# BCM

## Product Change Notice

<b>PCN Number:</b> 71131-H1-002		<b>Revision:</b> A		<b>Date of Publication:</b> 05/26/2016
<b>PRODUCT NAME</b>	<b>PRODUCT PART#</b>	OLD — REV. — NEW		<b>REVISION TYPE</b>
MX170QD	71131-IA	1.0	1.1	Hardware

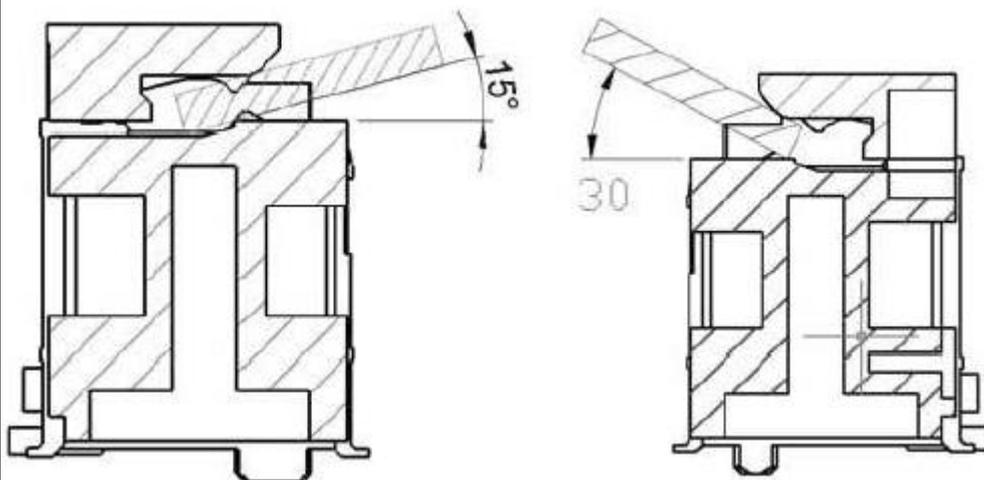
To make the M.2 connectors insertion angle more convenient for inserting M.2 cards.

Change M.2 connector to support a higher insertion angle.
